**Subject:** San Mateo Park Elementary School HVAC Replacement  
San Mateo - Foster City School District  
Aedis Project No. 2021011.08  
DSA Application #01-120214

### ADDENDUM NO. 1

San Mateo Park Elementary School HVAC Replacement  
San Mateo – Foster City School District  
Aedis Project No. 2021011.08

SHEET	
<b>ELECTRICAL SITE PLAN</b>	
DATE	
11/28/2022	
JOB #	
2021011.08	
SHEET #	
AD1- E1.1

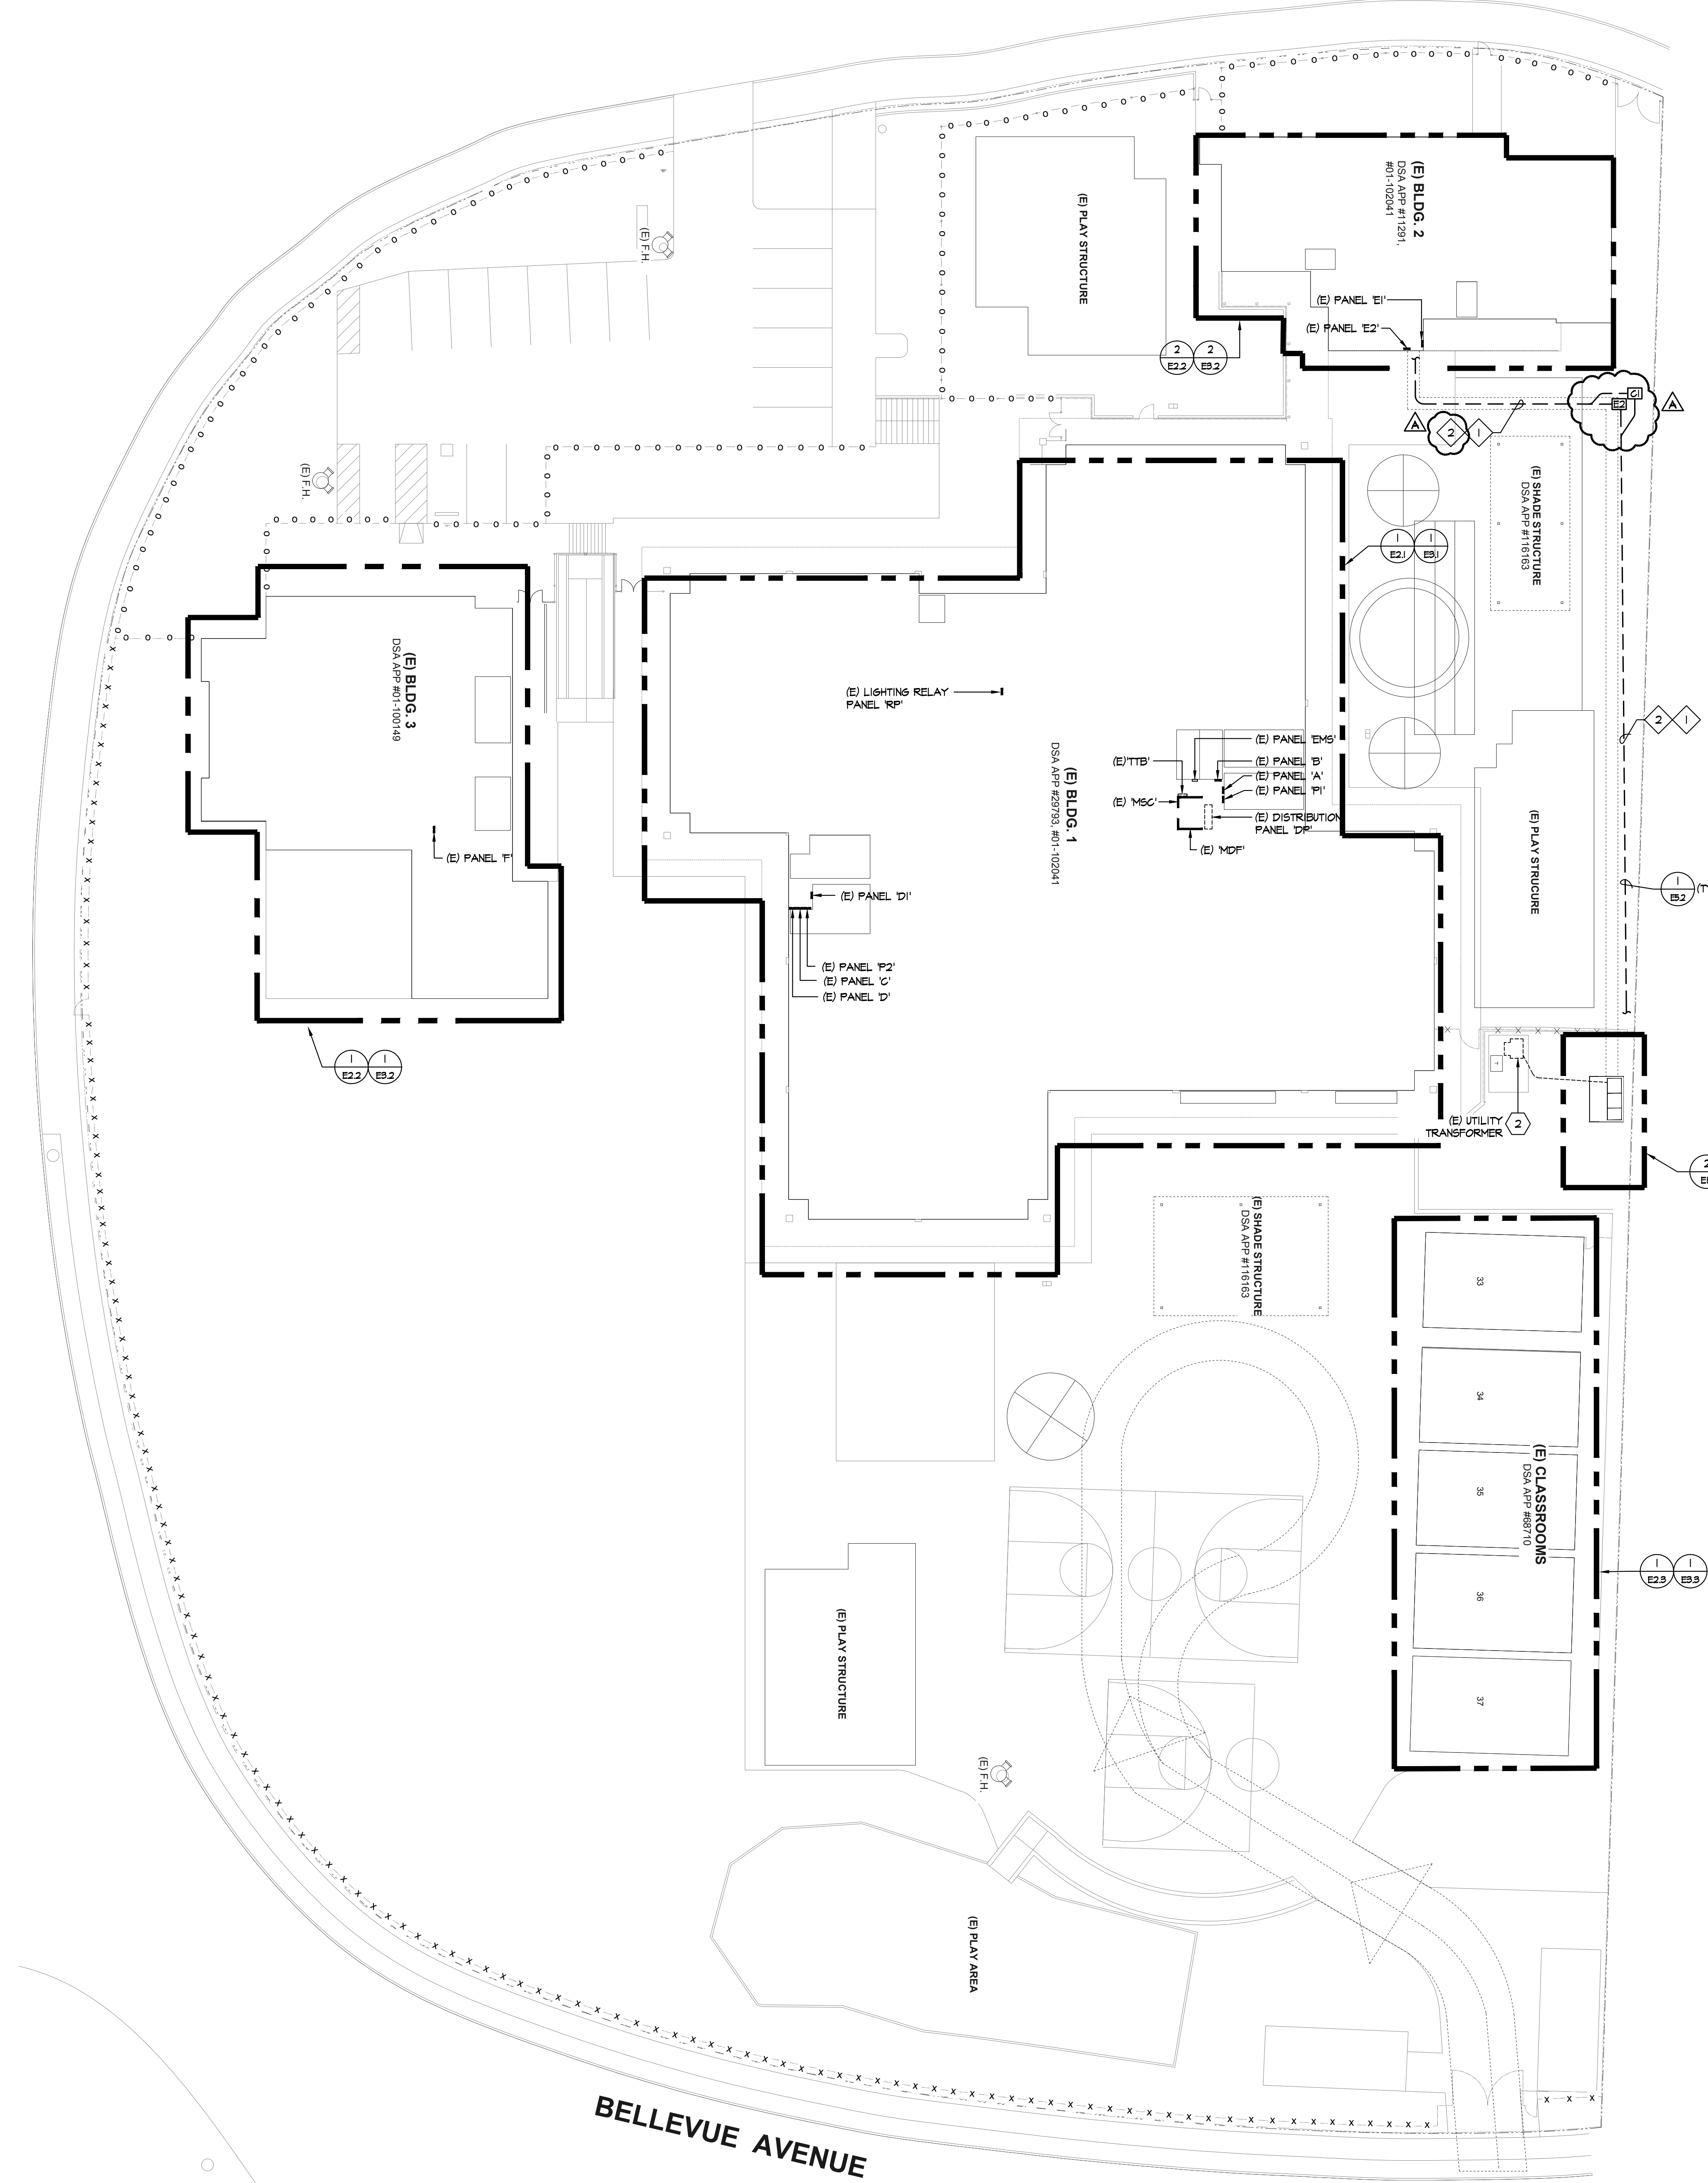
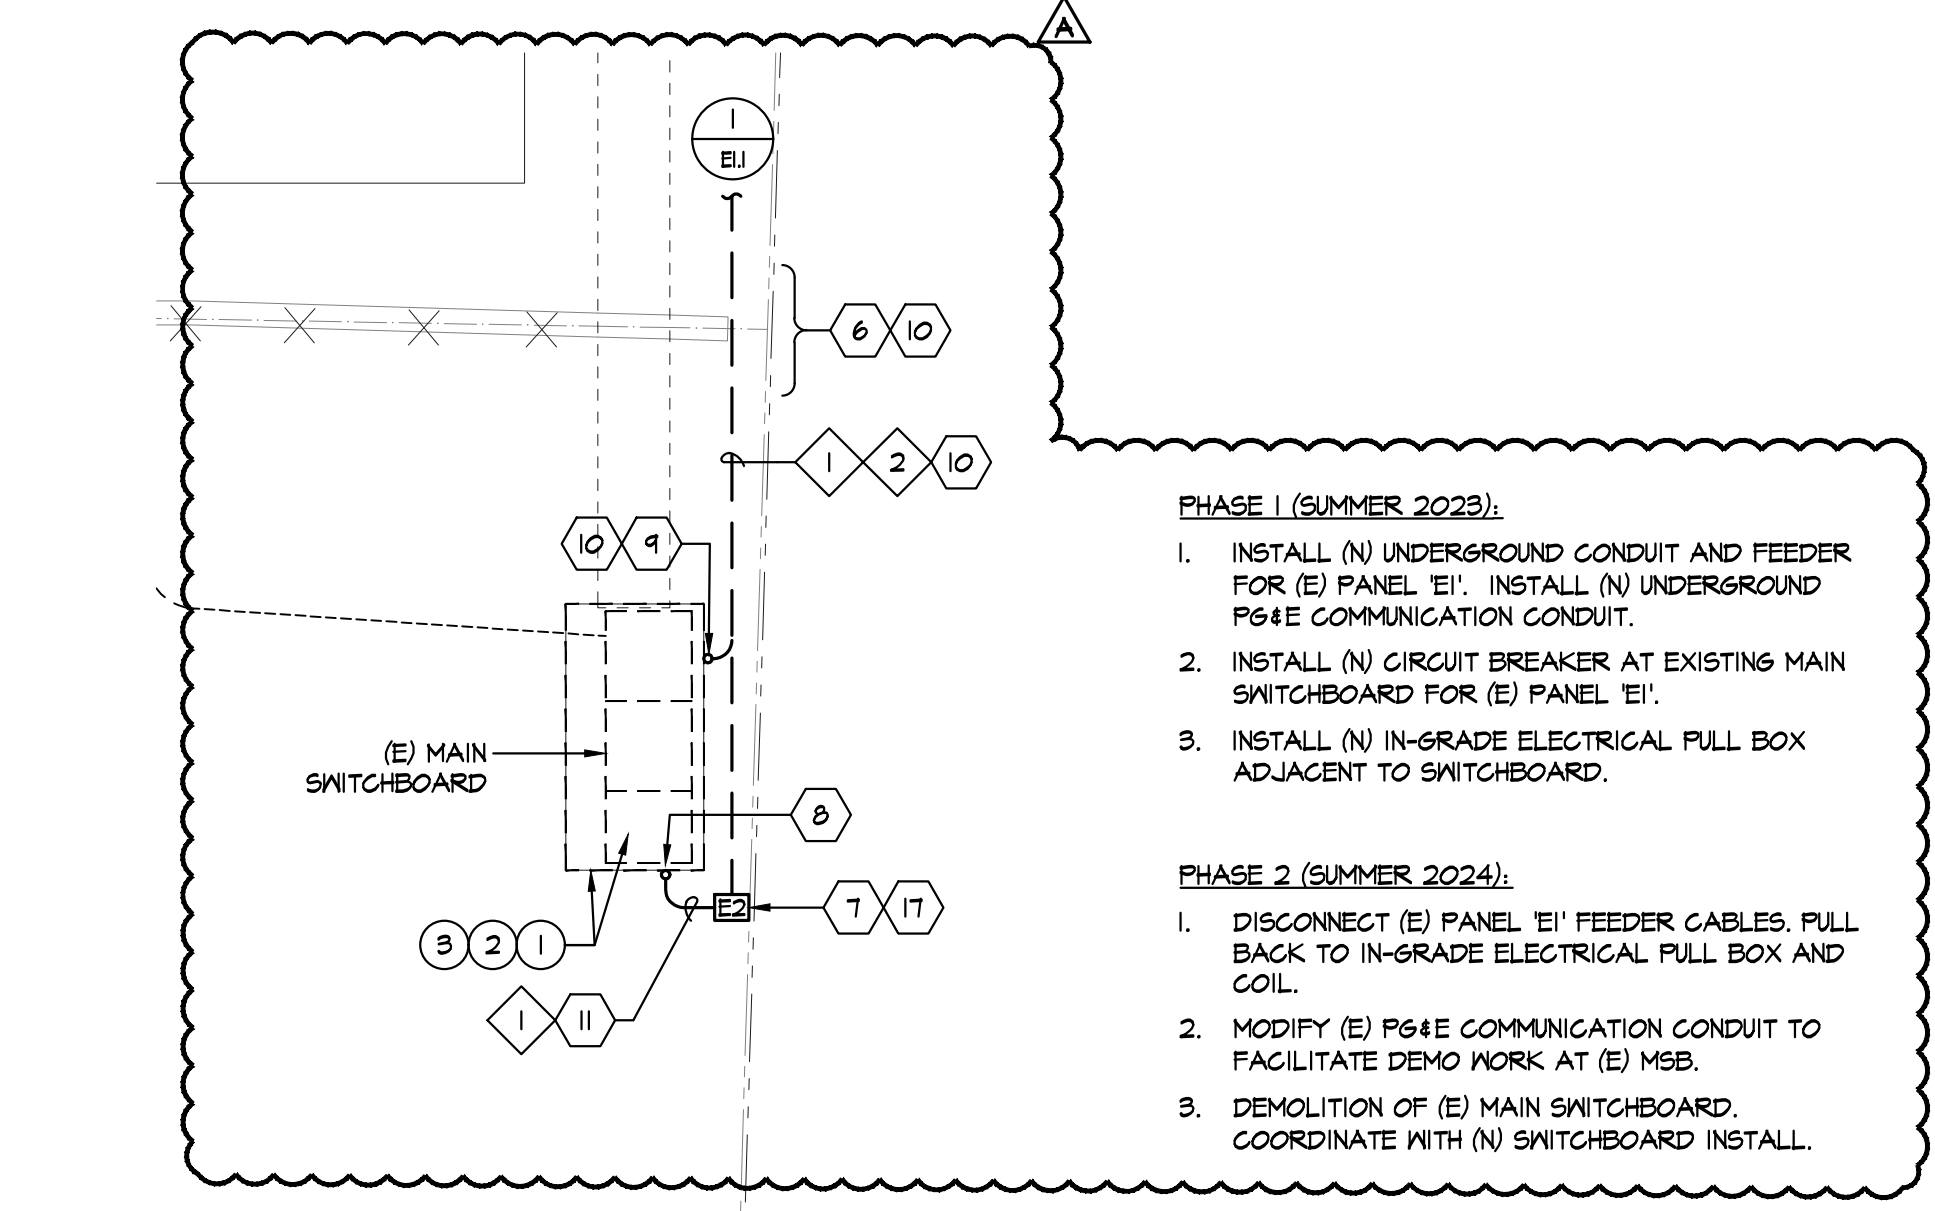
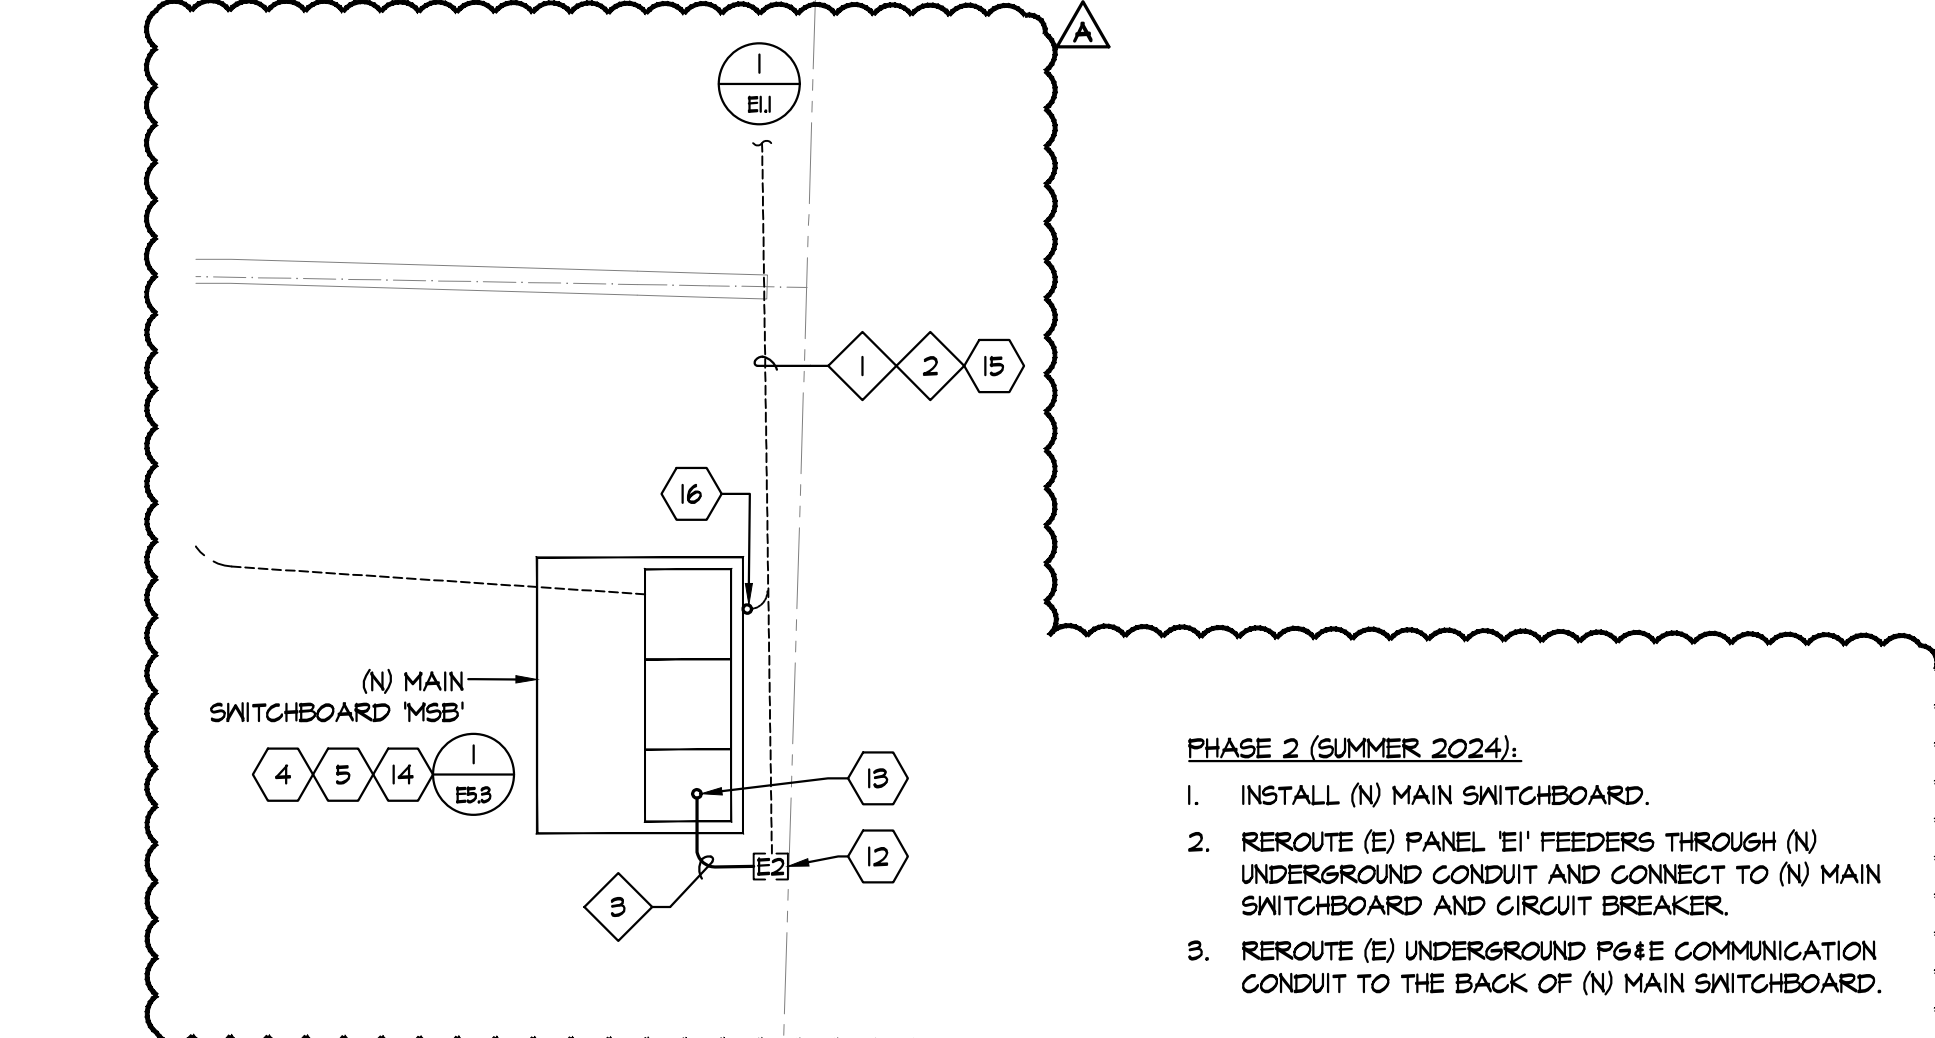
- Add: Conduit #2 and Pull box “C1” on electrical site plan as shown per AD1-E1.1.
- Revise: Enlarged Demo Site Plan & Enlarged New Site Plan as shown per AD1-E1.1.
- Revise: Conduit Schedule tag #2 as shown per AD1-E1.1.
- Add: Sheet Notes #7 thru #17 and associated tags in Enlarged Demo Site Plan and Enlarged New Site Plan as shown per AD1-E1.1.
- Add: Demolition Sheet Note #3 and associated tags in Enlarged Demo Site Plan as shown per AD1-E1.1.
- Add: Conduit Schedule tag #3 as shown per AD1-E1.1.
- Add: General Note #9 as shown per AD1-E1.1.
